TENNESSEE VALLEY AUTHORITY

Enclosed is Revision 3 of TVA's response to the Auxiliary Systems Branch (ASB) fire protection review questions for the Sequoyah Nuclear Plant. This information was requested in your letter to N. B. Hughes dated September 1, 1978. The original information, Revision 1 and Revision 2, was submitted by my letters to you dated November 9, 1978, December 19, 1978, and January 19, 1979, respectively. This revision includes:

AUXILIARY SYSTEMS BRANCH  
FIRE PROTECTION REVIEW  
SEQUOYAH NUCLEAR PLANT - UNITS 1 AND 2  
DOCKET NUMBERS 50-327/328

FIGURE 1.1  
SEQUOYAH NUCLEAR PLANT  
SHUTDOWN LOGIC - FIRE

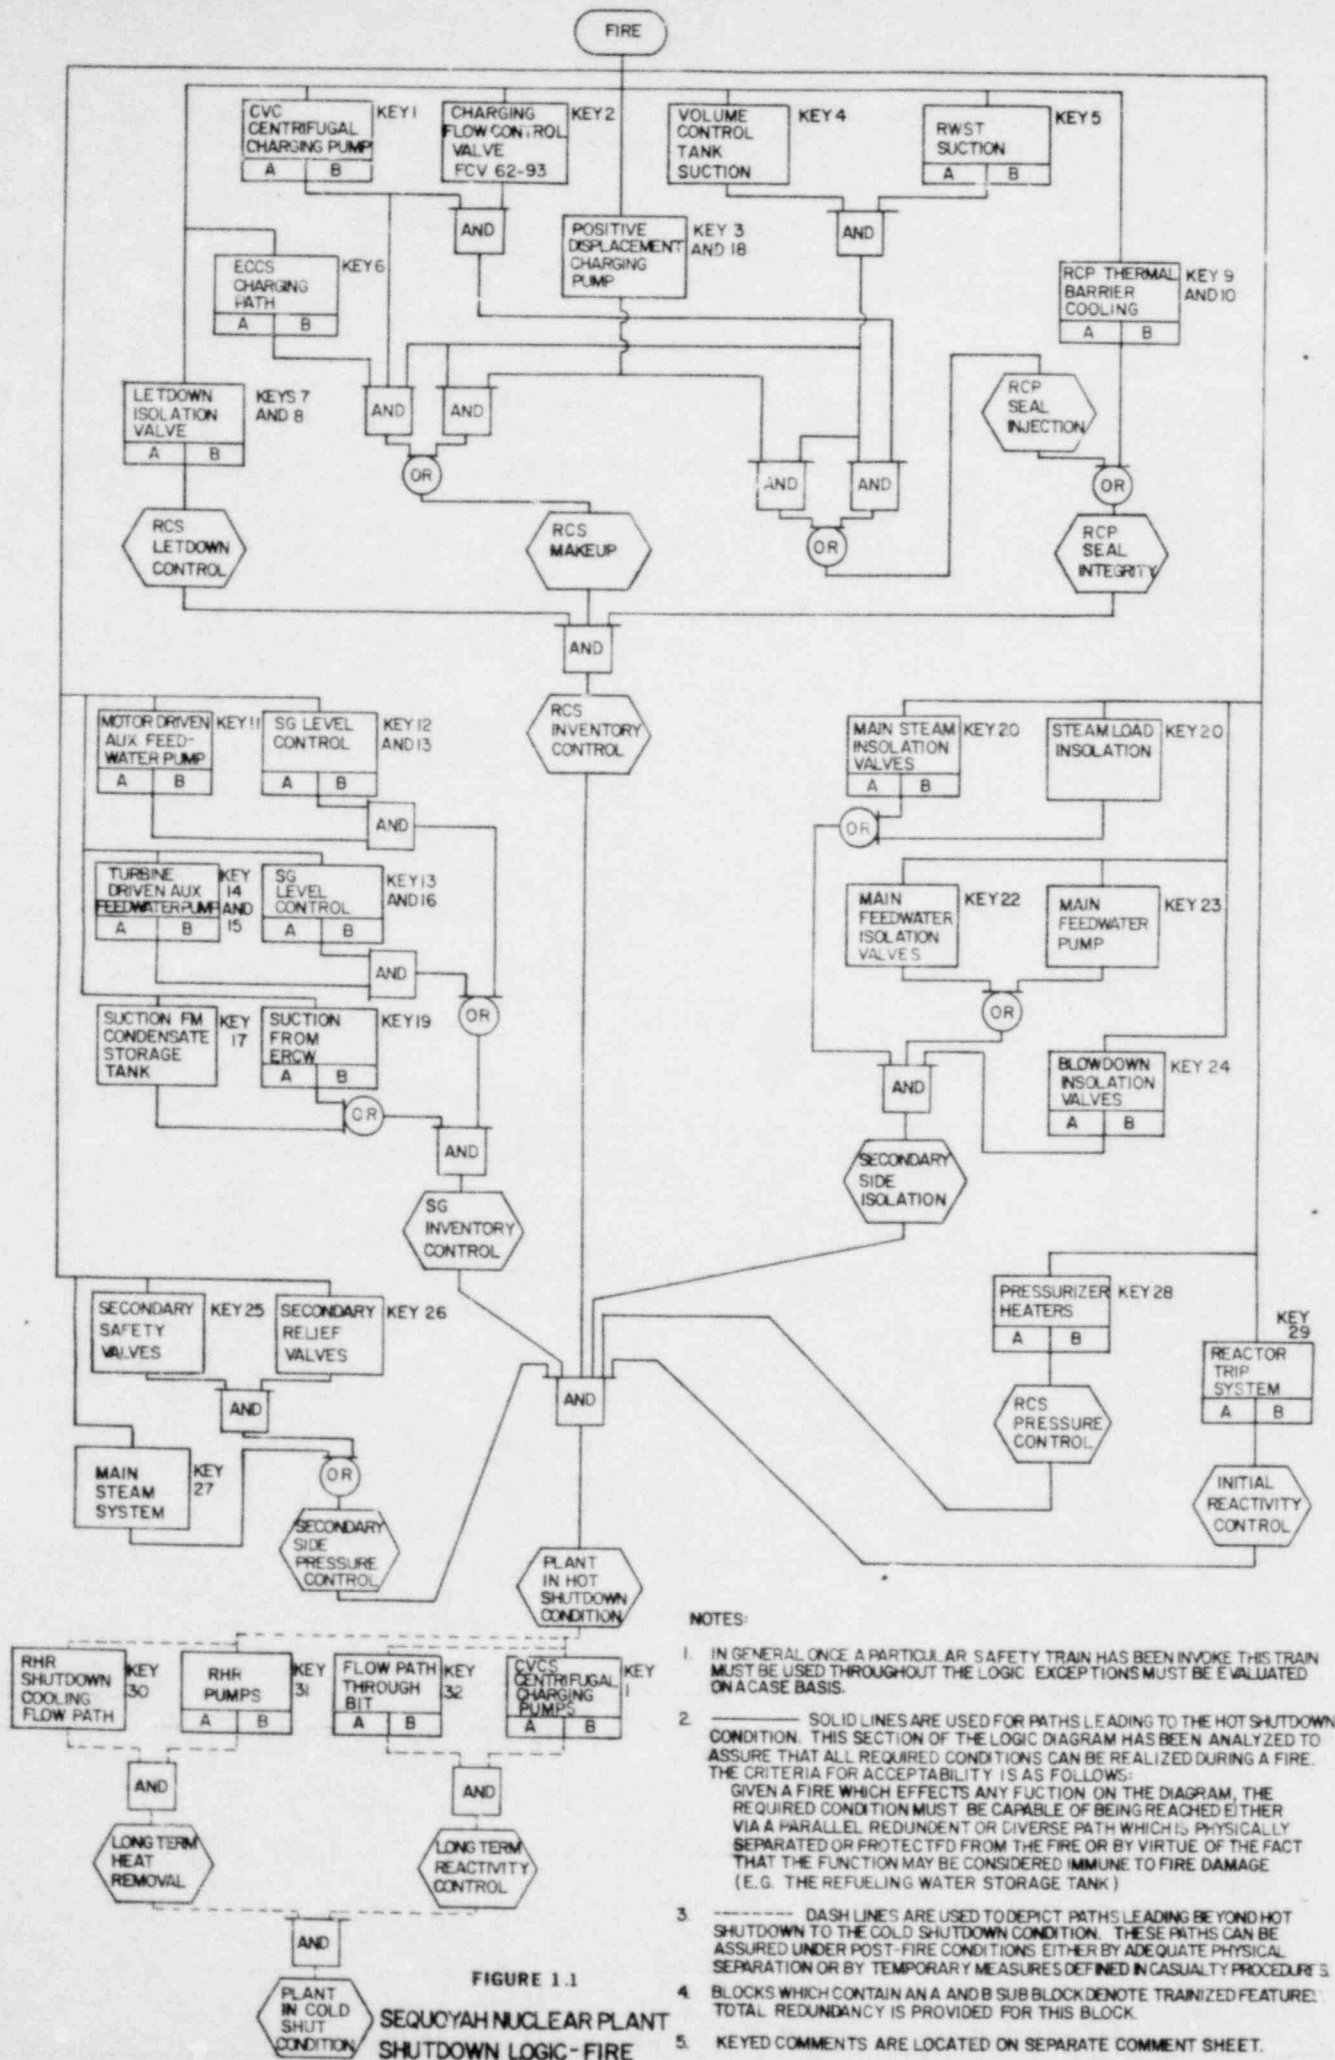
1. Your submittal provides only part of the information requested in Enclosure 2 to our letter dated September 30, 1976. A fire hazards analysis should be conducted for each plant fire area, and the effects of postulated fire involving permanent and/or transient combustibles on systems, circuits, or equipment required for safe plant cold shutdown should be evaluated. The fire detection and primary and secondary fire suppression systems for each area should also be indicated. In the fire hazards analysis you should identify all the redundant mechanical and electrical systems necessary for safe cold shutdown which are separated only by distance (no fire barriers). The fire hazards analysis should demonstrate that, assuming failure of the primary suppression system, a fire in installed or transient combustibles will not damage redundant trains or divisions of systems required for safe plant cold shutdown. Where this cannot be demonstrated, an alternate means of assuring safe plant shutdown (cold shutdown) should be provided.

Figure 1.1 is a safe shutdown logic diagram for a fire at Sequoyah Nuclear Plant. This figure and its comment sheet identify those plant features necessary to achieve and maintain a safe plant shutdown in the event of a fire. TVA has conducted an analysis of the plant based upon this diagram and its comment sheet assuming a postulated exposure fire with a zone of influence requiring a minimum 20-foot spatial separation of redundant equipment, circuits, or components in all plant areas outside of containment. This analysis has identified where additional protection

Throughout this discussion an asterisk (\*) will be used to identify the title of a function block on the shutdown logic diagram (Figure 1.1). This diagram and its keyed comments are germane and are an integral part of the following discussion.

The analysis noted that the single postulated exposure fire described above could cause the loss of both trains of the CVCS Centrifugal Charging Pump\* and the Positive Displacement Charging Pump\*. TVA will correct this unacceptable condition by rerouting the wiring for the positive displacement charging pump and the positive displacement pump room cooler in accordance with Table 1.2. This pump was chosen for rerouting because it is the pump used in normal operation; hence, its flow path is already properly aligned. The ECCS charging Flow Path\* associated with the centrifugal pumps contains interactions which can affect both A and B train sections. These interactions are acceptable because they do not affect the positive displacement charging pump, hence, either the positive displacement pump via the normal charging path or the centrifugal charging pump(s) via the ECCS path(s) are available during any postulated fire.

Control of RCS makeup via either the ECCS (centrifugal) pumps or the normally operating (positive displacement) pumps requires a pressurizer level signal. Unacceptable interactions were found to exist between conduits associated with the required instrumentation wiring. TVA will correct this condition in accordance with Table 1.3. The component cooling water and

essential raw cooling water systems are identified in the keyed comments as being required for RCS makeup. Unacceptable interactions do exist in both of these systems. The CCS mechanical system interactions and how they are resolved are discussed in the response to question 13. The CCS and ERCW electrical system interactions will be protected in accordance with Table 1.4.

Figure 3.E.(iii)-1

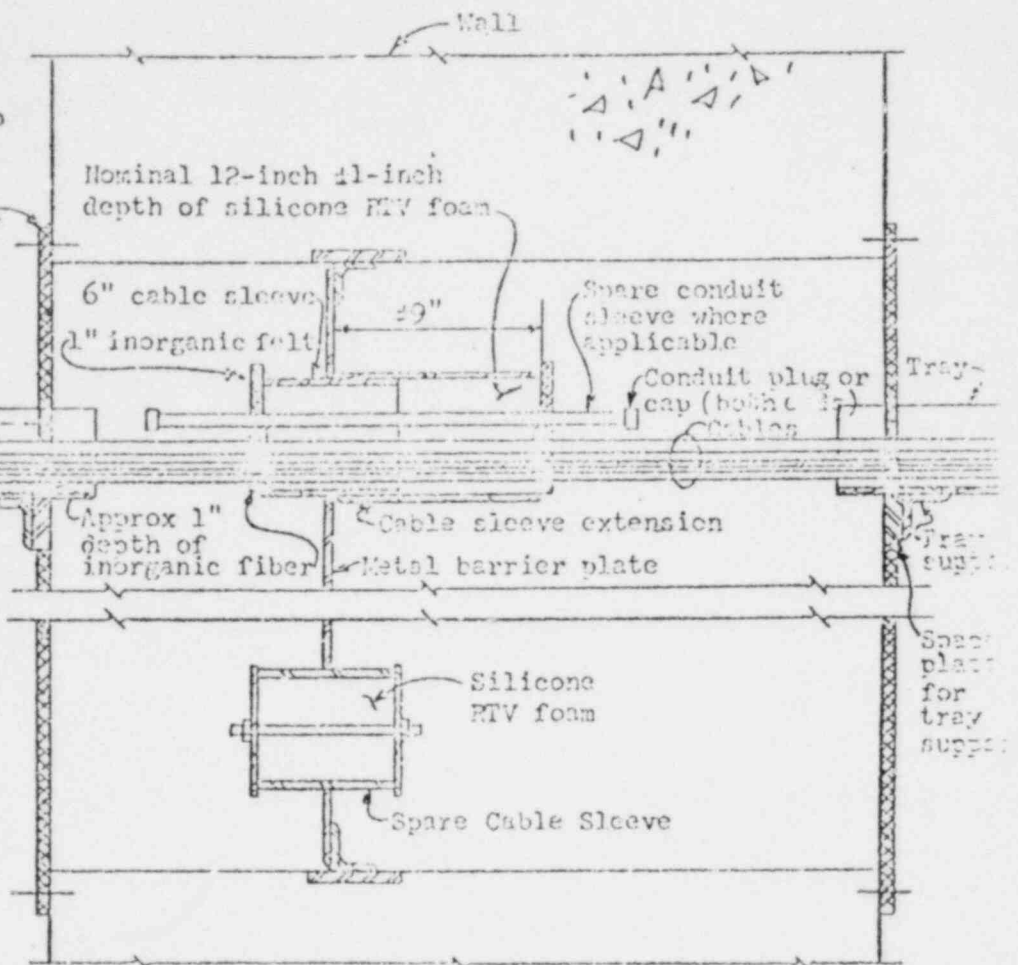
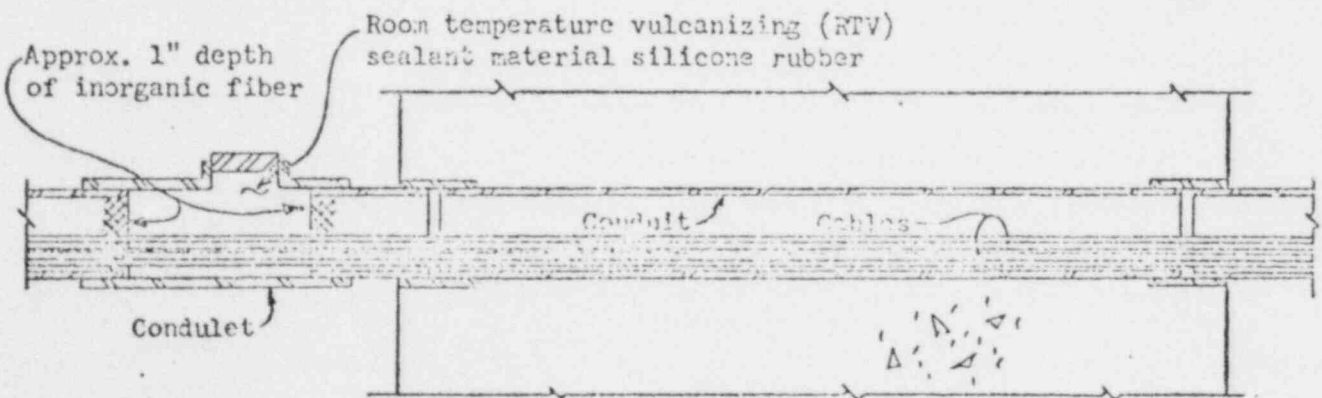
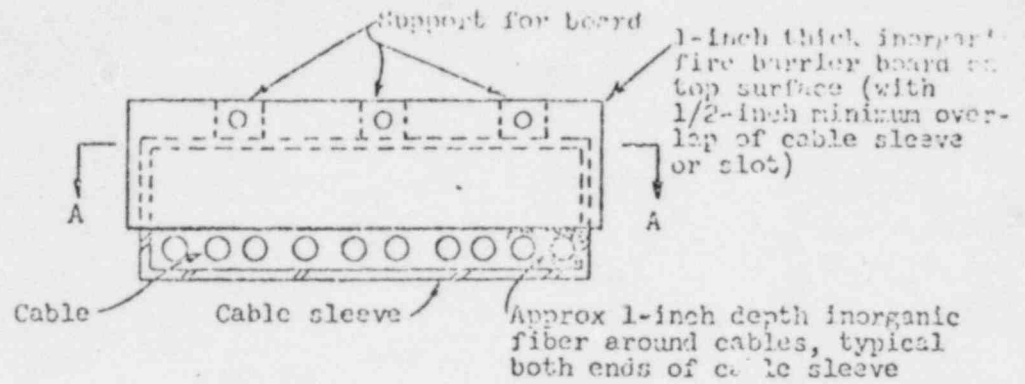
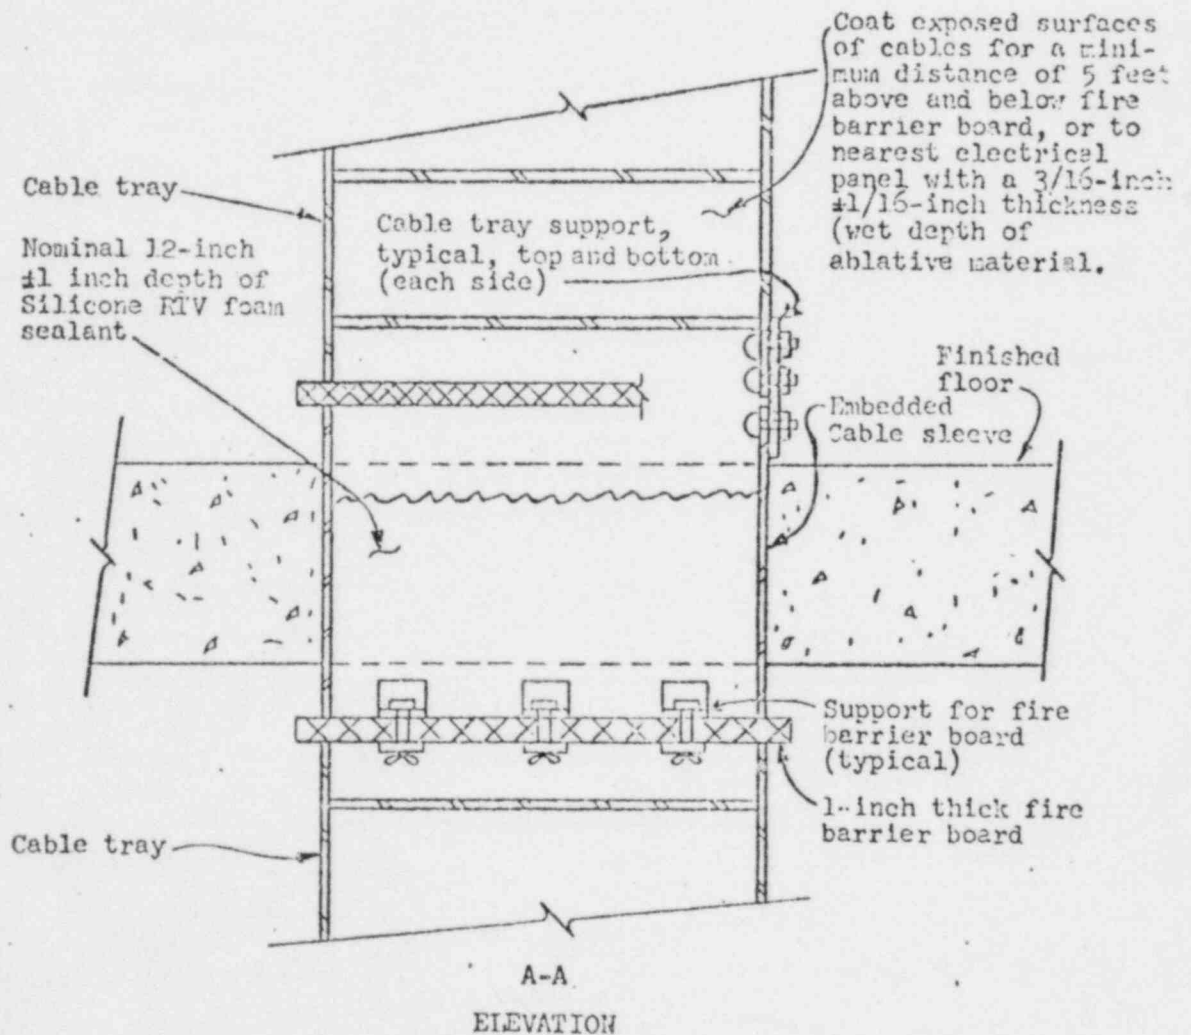
- (iii) Fire barrier penetration seals around ducts, pipes, cables, cable trays, and conduit or any other openings. Verify that the seals will meet the 3 hr. requirements for ASTM E-119. Verify that the inplant cable tray supports are similar to the ones used in the fire tests and that, in case of collapse of the trays, the resultant unsupported load and torque on the penetration seal will not affect the integrity of the seal.

The design of the inplant cable tray supports are typically shown in Figures 3.B.(iii)-1 and 3.B.(iii)-2 for wall and floor penetrations with cable trays, respectively. During the tests conducted by TVA, warpage of the cable trays and supports was observed to occur outside the cable coated area. No visual distortion of the cable trays or their supports was observed at the wall opening following the test.

FIGURE 7-1

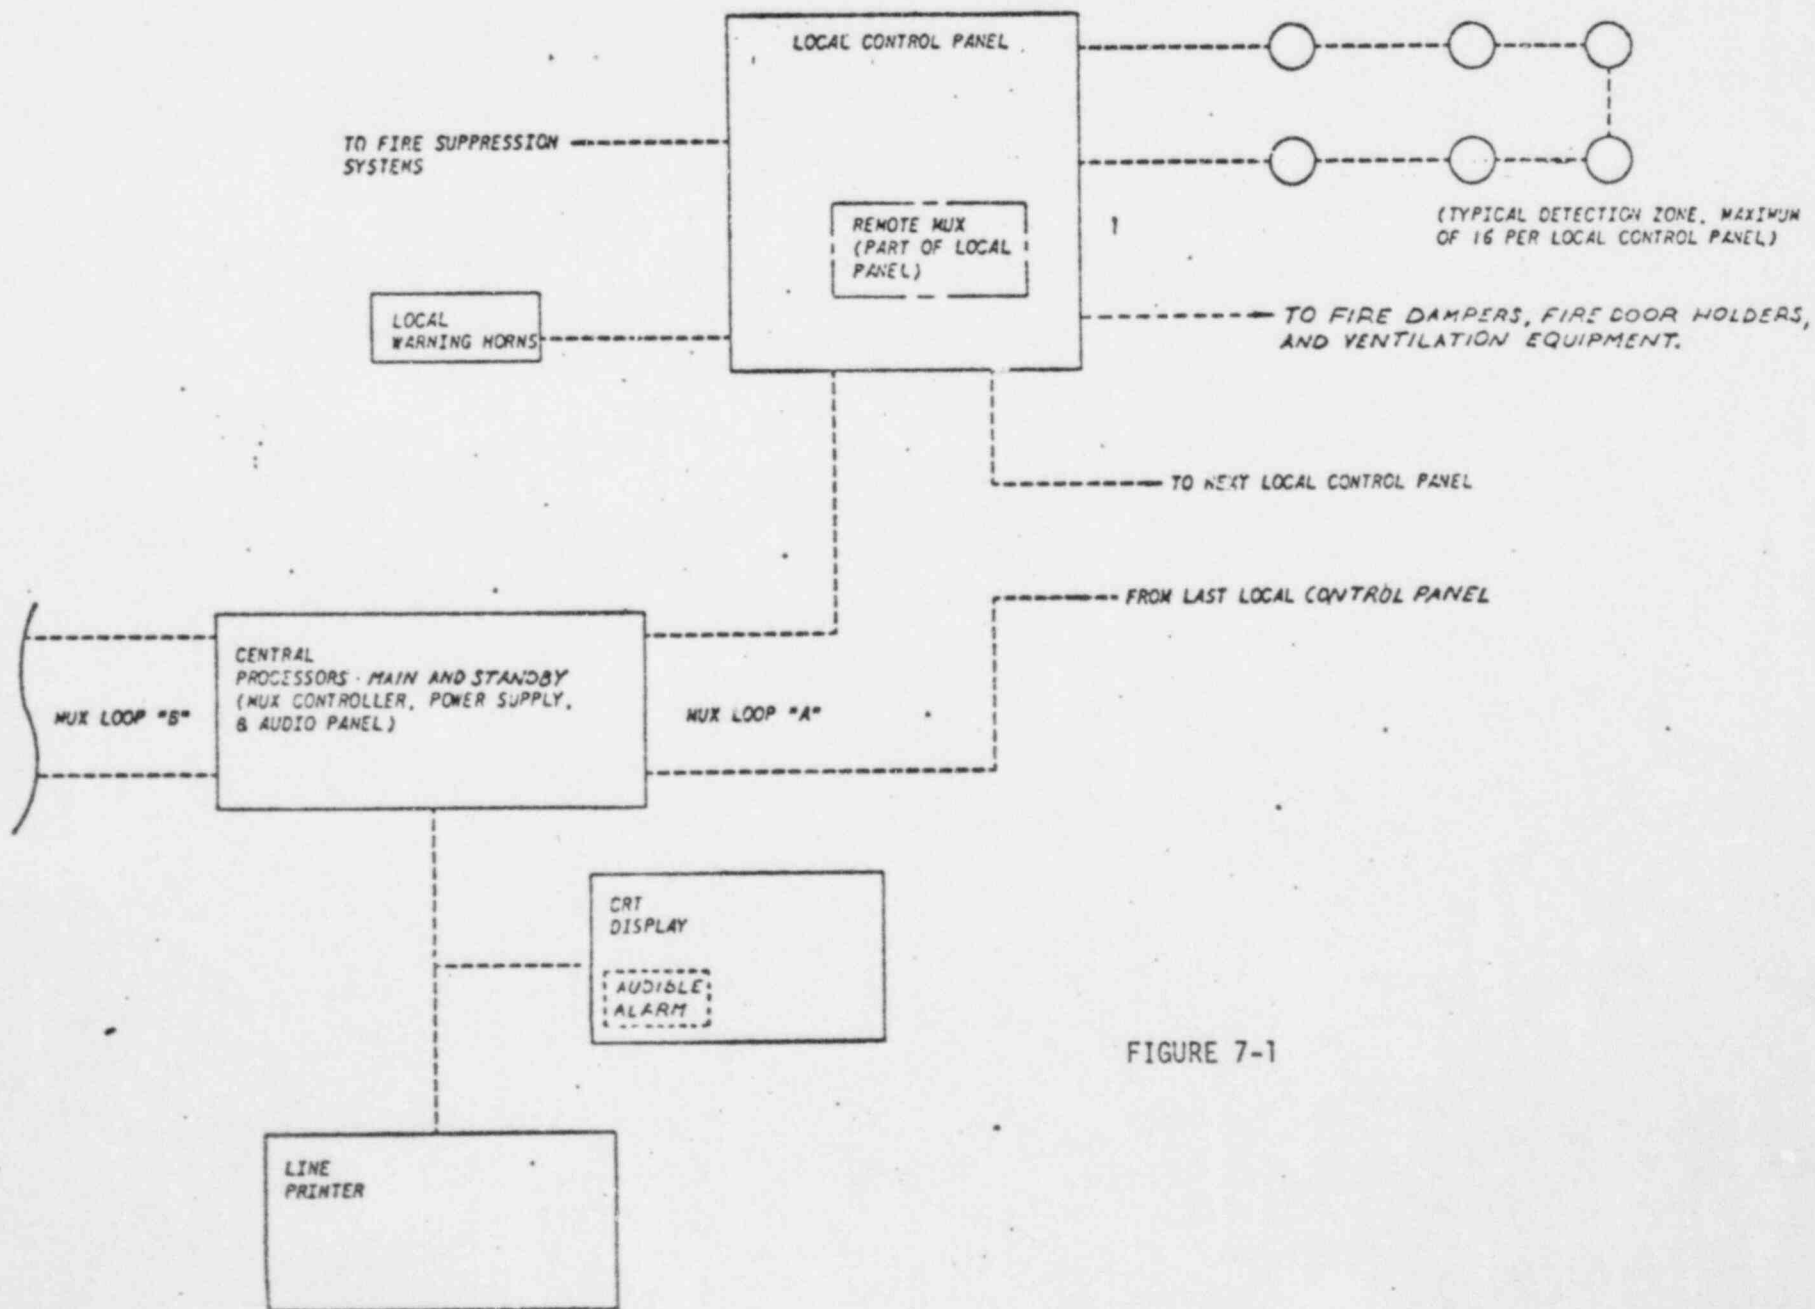
7. Item E.1, Fire Detection - Your description of the fire detection system is incomplete. Describe the type of detector provided for each room or area containing safety related equipment or systems. Also, provide a detailed description of the fire detection system, supported where necessary, by diagrams or appropriate prints (include a single line drawing from the detection circuits, waterflow alarms, through the subpanels and into the control room).

The fire detection system complies with the requirements of BTP 9.5-1, Appendix A, and is designed in accordance with NFPA 72D and 72E. The system consists of initiating devices, local control panels, remote transmitter-receivers providing remote multiplex (MUX) functions, and computerized multiplex central control equipment. Refer to Figure 7-1 for a block diagram of the system.
